Report of 4th Pilot audit of Transmission Tower by the audit team of the committee for Audit of Transmission Tower

Sub: Observations of 4th pilot audit of transmission line towers – Reg.

Deflections Report of the Transmission Line Towers

Fig. 3 – 1 for Towers
Audited on 16/01/2019

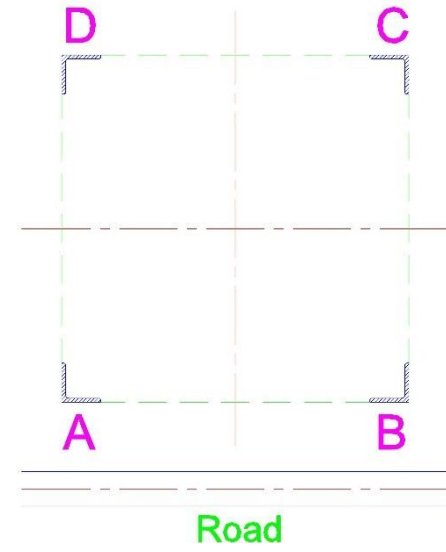
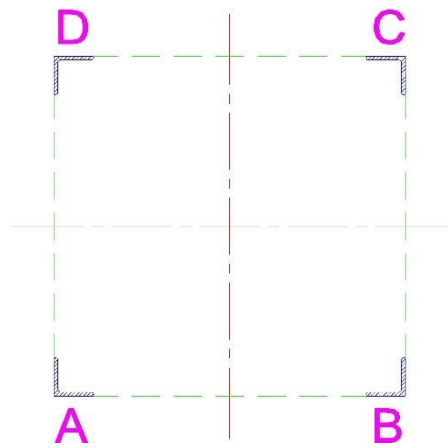
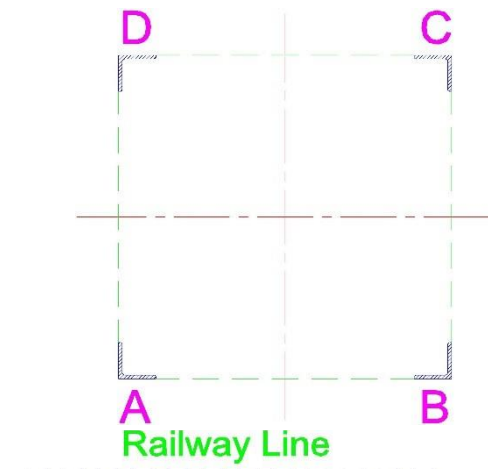
Table-1 4th Pilot Audit for Audit of Transmission Line Towers - Details of Member Section Dimensions								
Audit Date	Trans. Line & Agency	Tower No.	Tower Member	Member Section Dimensions				Refer Tower Location Figure
				Leg-A	Leg-B	Leg-C	Leg-D	
16-01-2019	400 kV Seoni - Sarni Transmission Line M/s MPPTCL	1	Stub	L 150.60x147.66x12.96x12.60	L 149.90x149.40x12.64x12.20	L 149.94x149.12x12.42x12.64	L 149.52x150.52x12.12x12.12	Fig. 3 - 1
			Leg	L 148.90x150.18x11.98x11.88	L 150.62x150.40x11.68x11.94	L 149.34x149.82x12.12x12.82	L 149.62x151.10x11.82x12.42	
			Trans. Bracing	L 99.90x100.80x6.40x6.66	L 99.86x99.42x6.18x6.14	L 99.12x99.52x6.22x6.42	L 99.22x99.82x6.92x6.86	
			Long. Bracing	L 91.12x90.42x6.20x6.66	L 91.90x90.10x6.60x6.42	L 91.72x89.42x6.52x6.72	L 91.22x90.34x6.82x6.62	
		2	Stub	L 150.42x151.94x15.92x16.12	L 152.14x152.12x16.12x15.96	L 152.42x151.62x15.92x16.18	L 152.42x152.22x16.42x16.92	Fig. 3 - 1
